Addendum No. 2

City of Coquitlam
Tender 81293

Oakdale Park Stormwater Treatment Facility

Issue Date: April 16, 2024
(Consists of 4 Pages)

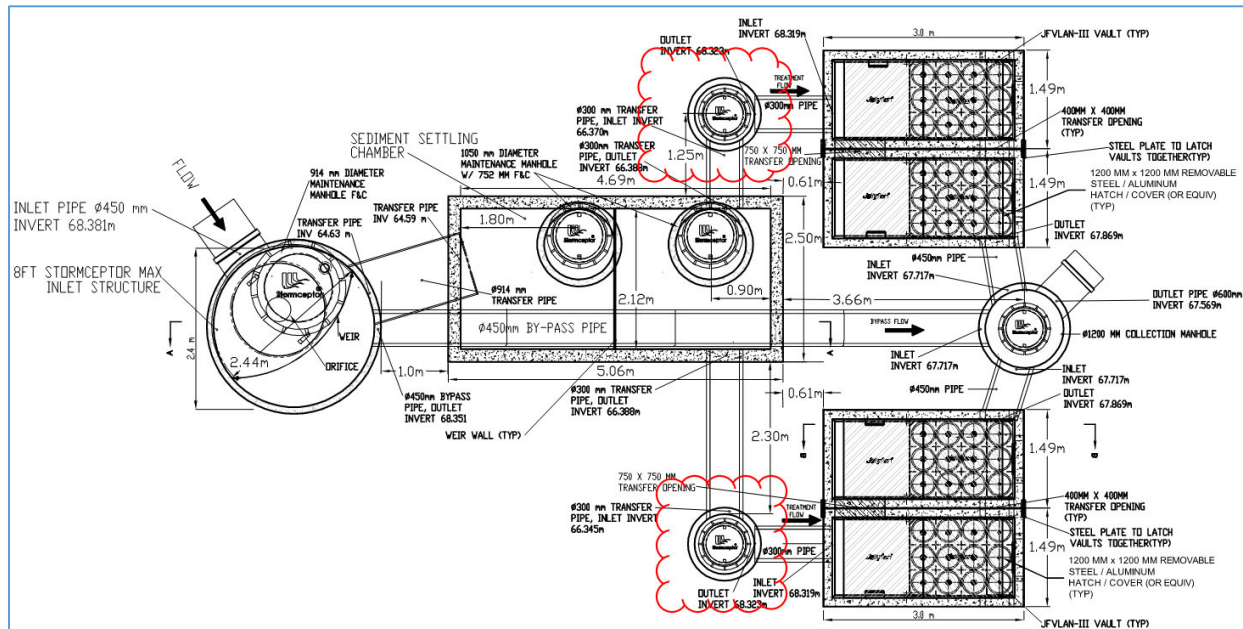
- Q3) Confirm the MH depth of the manholes (red clouded) in the drawing below. Confirm whether these manholes are sumps. Confirm if there are unique numbers to these manholes:

- A3) There is no unique numbering for the noted manholes (e.g. DXX) because both manholes are considered part of the proposed Storm Water Treatment Facility system (Pay Item 17.12).

Imbrium confirms that a 300mm deep sump shall be located below the 300mm inlet pipe inverts in these manholes.

The depth of the marked manholes will be 5.6m (from Rim elevation to sump elevation).
